SUBJECT: RHODE ISLAND ATOMIC ENERGY COMMISSION – CORRECTION TO
AMENDMENT NO. 30 TO FACILITY OPERATING LICENSE NO. R-95,
RHODE ISLAND NUCLEAR SCIENCE CENTER (TAC NO. MF1044)

AMENDMENT TO FACILITY OPERATING LICENSE

Amendment No. 30
License No. R-95

SAFETY EVALUATION BY THE OFFICE OF NUCLEAR REACTOR REGULATION

FIGURE 6.1 - ORGANIZATIONAL CHART

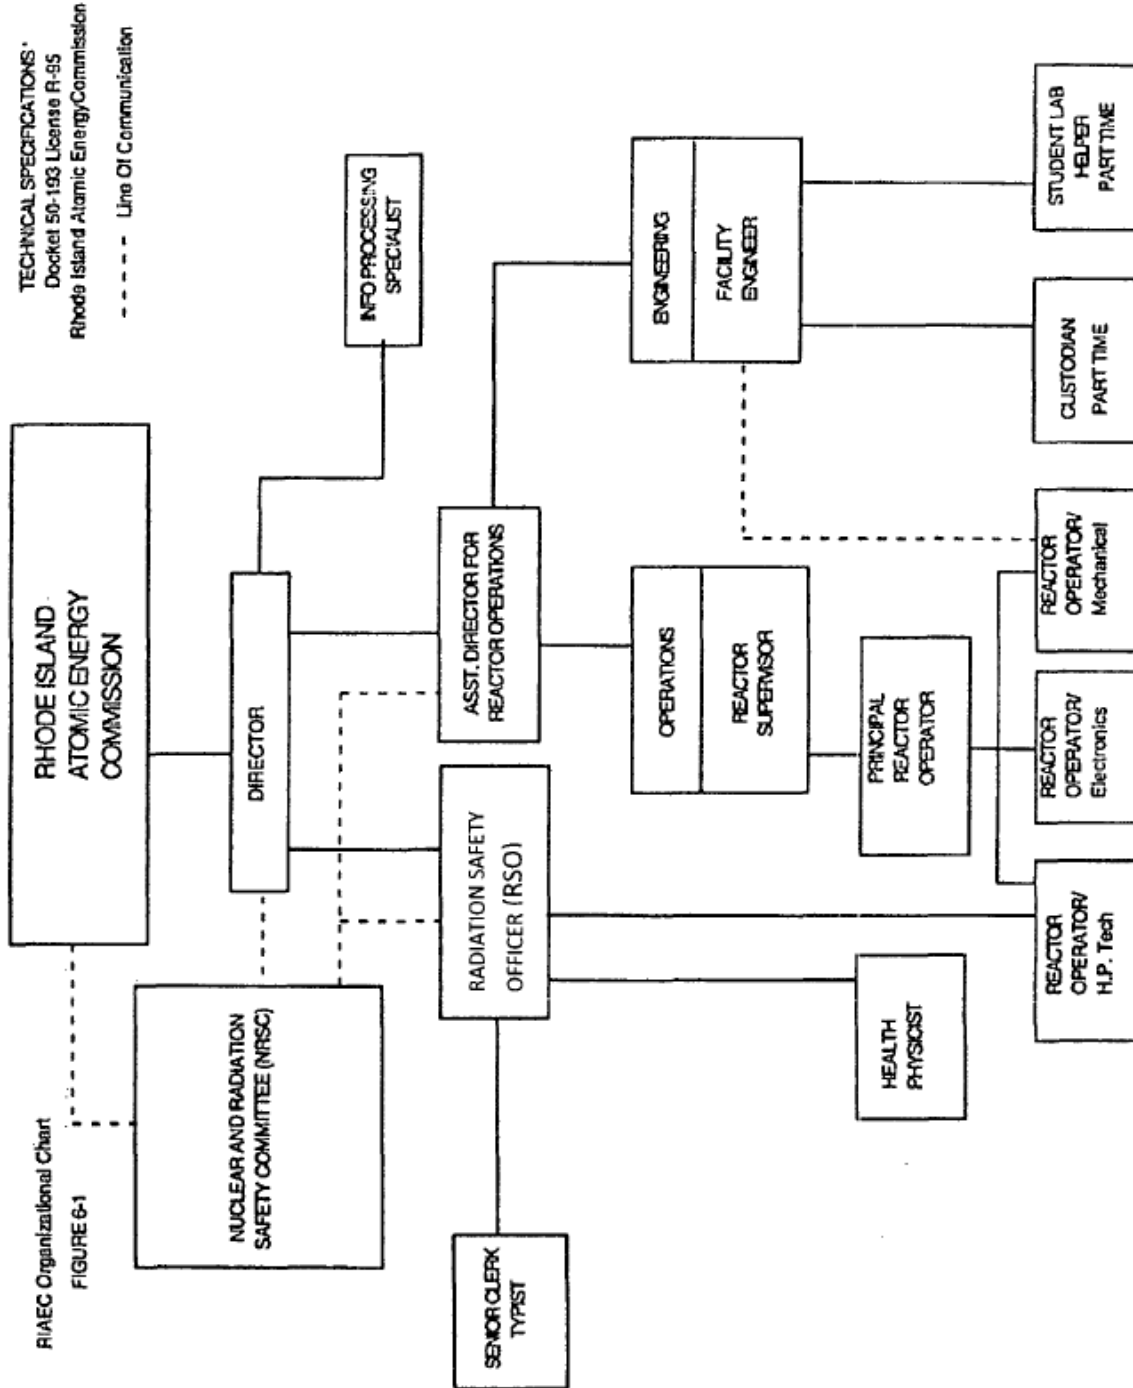
The licensee proposed an amendment to change TS 6.1, "Organizational Chart," which changes the title of Assistant Director for Radiation Safety.

The current RINSC TS 6.1, has the following title:

- Assistant Director for Radiation Safety (Radiation Safety Officer)

In its letter dated February 7, 2013, the licensee has requested to change the title to:

- Radiation Safety Officer

The licensee stated that the proposed title change will bring clarity to the organizational chart, and will have no impact on the RINSC as the position description, responsibilities and authority of the radiation safety officer remains the same.

The U.S. Nuclear Regulatory Commission (NRC) staff has reviewed the licensee's submission and the previously issued license amendment histories, and concludes that the change is acceptable and will not affect facility operations. The radiation safety officer's roles, responsibilities, and reporting chain will remain the same as in the current organizational chart. The NRC staff agrees with the licensee's assessment that this requested change is administrative and it is a RINSC internal personnel classification matter. Based on the foregoing analysis, the NRC staff concludes that the requested amendment will not change reactor operations or environmental monitoring procedures and requirements, and involves no

undue risk to the health and safety of the public or the environment. Therefore, the proposed change to TS 6.1 is acceptable.
